Re: **Attached Comments and Responses on Draft Environmental Impact Report
Case No. 2007.0206E: Sutro Tower Digital Television Project**

SUTRO TOWER DIGITAL TELEVISION PROJECT

Comments and Responses on Draft EIR

Planning Department Case No. 2007.0206E
State Clearinghouse No. 2008012005

Exhibit 1. Approx. 770 ft. Fall Zone

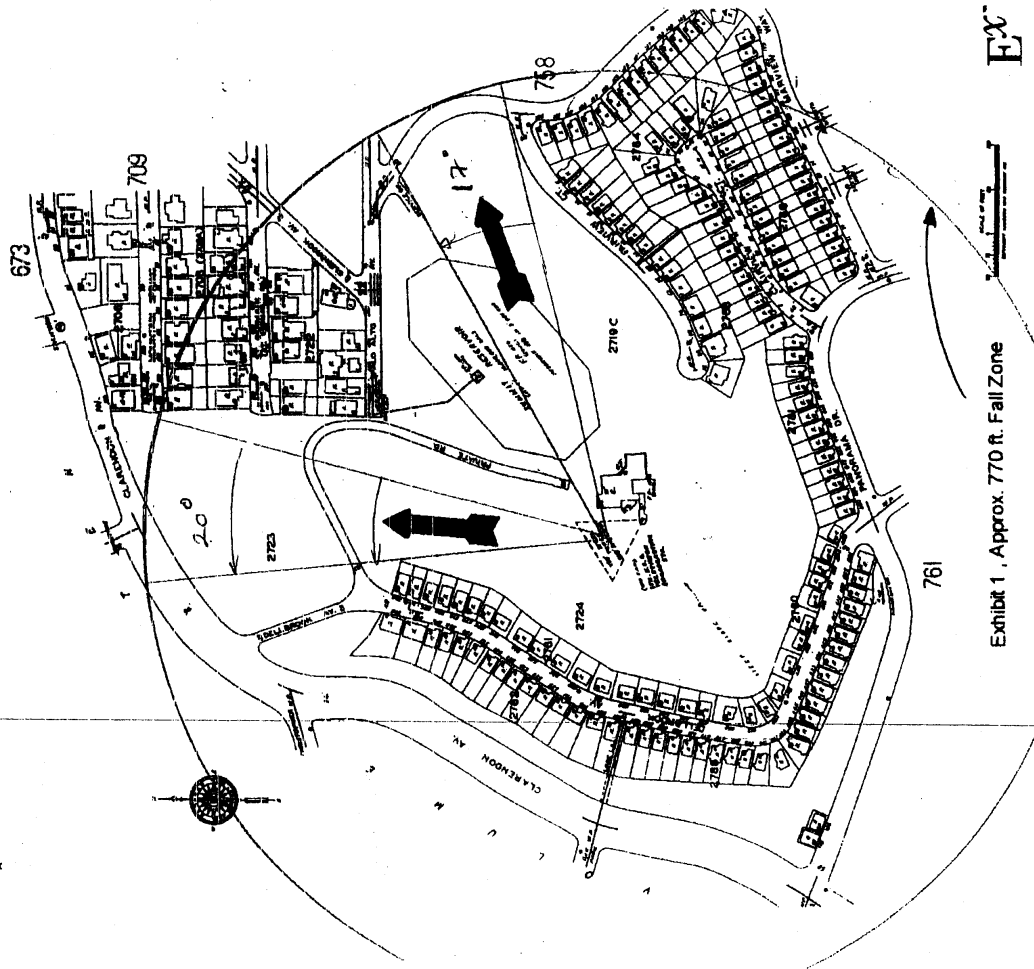
³ At the risk of sounding overly caudal, its collapse during a major seismic event would probably only add incrementally to the damage and fatality count.
⁴ As part of the PRA, the electromagnetic and pollutions hazards should also be quantitatively addressed.
